DEPARTMENT OF THE ARMY
U.S. ARMY GARRISON
FORT McCLELLAN, ALABAMA 36205-5000

This letter transmits responses to comments provided by the Department on March 28, 2005, regarding partial review of the Draft Engineering Evaluation/Cost Analysis, Bravo Area of the Redevelopment Area, document dated December 3, 2004, and requests your concurrence with the Army's recommendation for No Further Action in the M3-Remainder Area-PR of the Bravo Area.

Response to ADEM Review Comments on Proposed NFA Areas
Draft – Bravo Area EE/CA December 2004
Fort McClellan, Alabama

Grid C85 and Surrounding Grids
Eastern Bypass

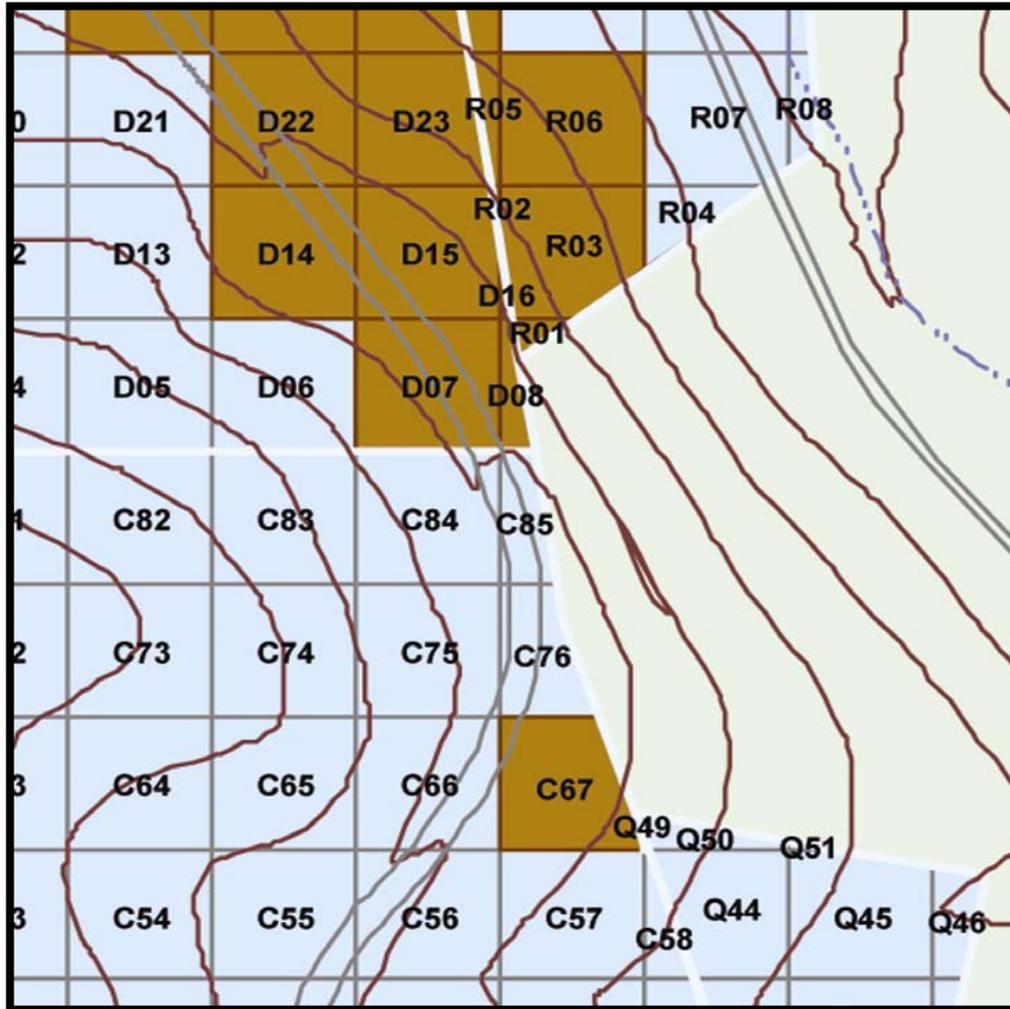
Additionally, grid C85 of the Eastern Bypass (EBP) Removal Project contained a 40 mm HE projectile (page 1-2 line 45). In the June 4, 2004 response to ADEM Review Comments on the *Draft Final Addendum to the Final Site Specific Work Plan Bravo Area EE/CA Ordnance and Explosives Response*, comment 4, part of the Army's response was "The 40 mm HE round in grid C85 will be treated as if it were found in the NFA area. A grid as described in the work plan will be investigated in this location". There is a grid (No. 171) located between the border of the Eastern Bypass and Yahoo Lake. However, it is unclear from the work plan or the Bravo EE/CA report if Grid 171 was the aforementioned proposed grid, and the reasons why this location was chosen for the grid.

Furthermore, it appears from the Bravo Area EE/CA Overview map that grid 171 was actually a half-grid, and very little other investigation is evident in the area near the 40 mm round find. Please clarify why the grid was not placed as close as possible to the 40 mm round find, and why the 40 mm HE round was not treated like the items found in R54, R51, and R48.

The 40 mm round was found on the side of a road in Grid C85 of the Eastern Bypass. This 40mm round was a single item. At the February 2004 meeting, ADEM and the Army agreed it would be sufficient to investigate a 50x50 grid around the item with the location of the round as the center of the western border of the grid. No OE or OE scrap was found in the grid. This 50x50 grid was not shown on the map and will be added. While performing the clearance to depth in the Eastern Bypass no OE or OE scrap was found within 200 feet north, west, and south of the 40mm item.

Army Response: Grid 171 is not the grid that was investigated in response to finding the 40mm item. The grid that was investigated as a result of the 40mm item was not shown on the map and will be added. Following the February 2004 meeting, the ADEM representatives agreed the Army could investigate a 50x50 foot grid placed in the NFA area with the location of the 40mm item as the center of the western border of the grid. In the 50x50 foot grid, no OE anomalies were found; and two non-OE anomalies were found. The rationale for investigation of only a 50X50 foot grid into the Bravo area is that there was no OE or UXO found in a 200 foot area of the Bypass to the north, west, and south of Grid C85 during characterization of this area between December 2001 and March 2002. The attached file (Attachment 6) shows all items found in grid C85 and the 22 grids and partial grids in the Bypass within 200 feet of grid C85. The only OE item found in any of these grids was the 40mm grenade in C85. A total of 87 mapped anomalies were intrusively investigated in these grids including 10 that were selected as QC digs. These 87 anomalies were located in 10 grids. Fifteen grids were either partially or totally "mag & dig" due to terrain. There were no anomalies identified in three of the grids. A significant portion of the anomalies were associated with construction debris under Iron Mountain Road. Only 5 of the mapped anomalies were OE related and 4 of those anomalies were OE Scrap. One of the OE scrap items was identified as 60 mm Mortar, HE Fins. Two additional items are identified as "frag" (one Misc Frag and one Signal, Illum, frag). It is clear the term "frag" does not refer to HE Frag but instead is used as short hand for fragments. The usage of "fragmentation" represents a general description of OE Scrap as derived from the definition for OE Scrap previously used by the Department of Defense for classification of all OE debris which could not be classified as UXO, OE, or non-OE scrap.

**FIGURE 4-2
M3-Remainder Area-PR
CONCEPTUAL SITE MODEL**

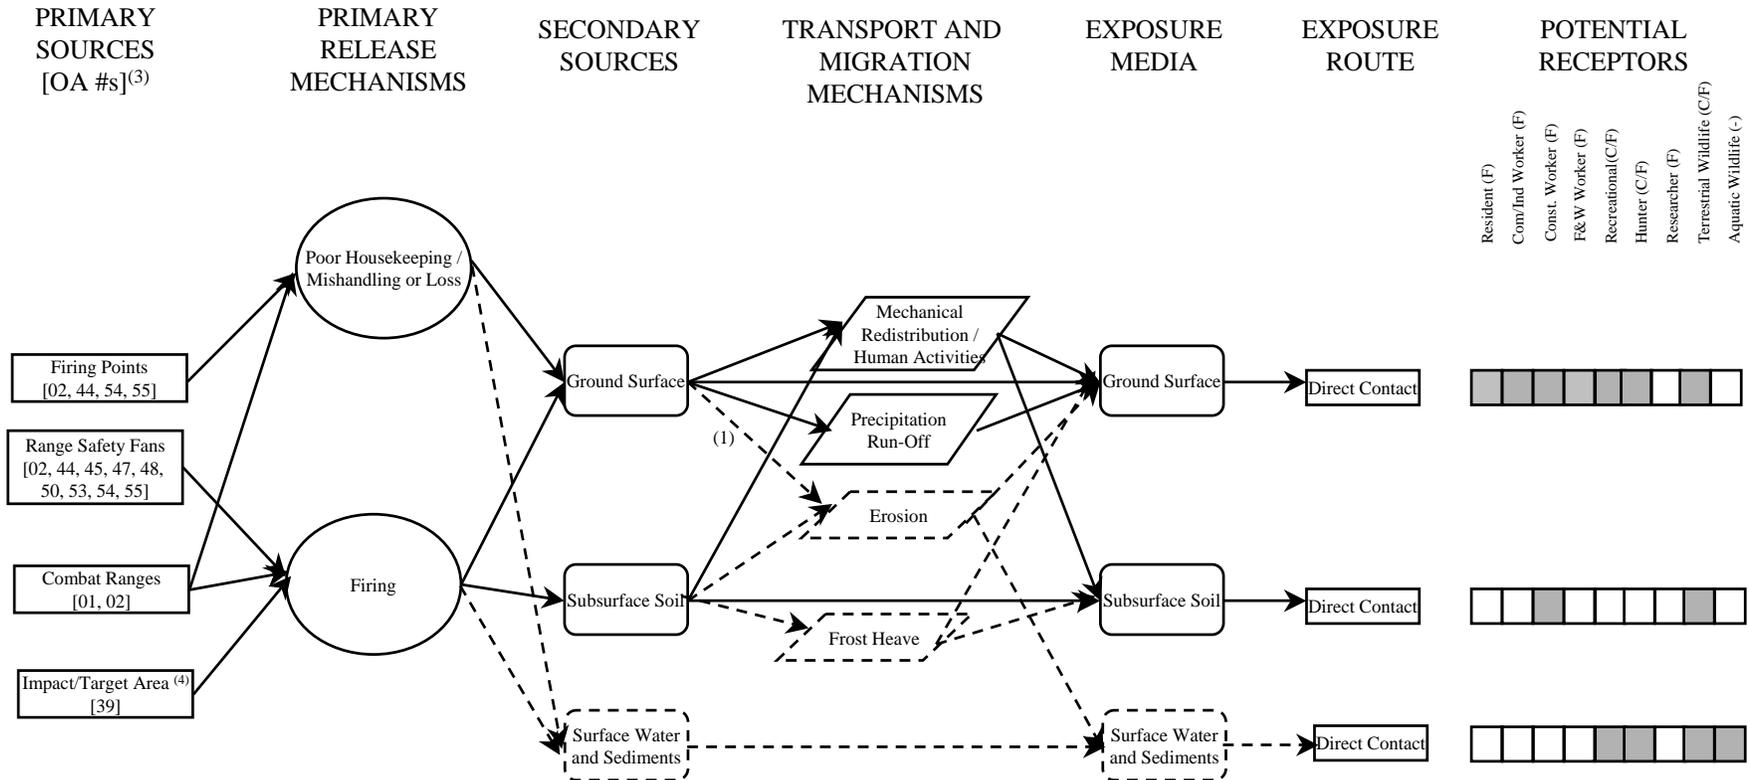
- b. The Conceptual Site Model does not include OA#45, Range 16. A good portion of this range is located in the northern portion of the proposed NFA area known as M3-Remainder Area-PR. Items that were found in Range 16 included rockets, small arms, and 40 mm grenades that ADEM understands are very sensitive. Please correct the Conceptual Site Model, update affected data throughout the text, and if affected, revise the boundary of the proposed NFA area accordingly.

Army Response: ADEM is correct. Part of OA-45 is in the NFA area. The revised CSM is included as Attachment 7 to this response. The addition of OA-45 does not change the outcome of the risk assessment because the Risk Assessors did not use OAs in the analysis. Originally these OA's were used to make the initial high, low, and medium boundaries when the sampling plan was developed. After characterization began, the characterization data was used to classify the risk sectors. The OA's are included on the CSM for historical information. The current boundaries are due to what was found in the characterization process and have already been adjusted. Investigation in the part of OA-45 that extends into the NFA area did not yield any items with an explosive hazard.
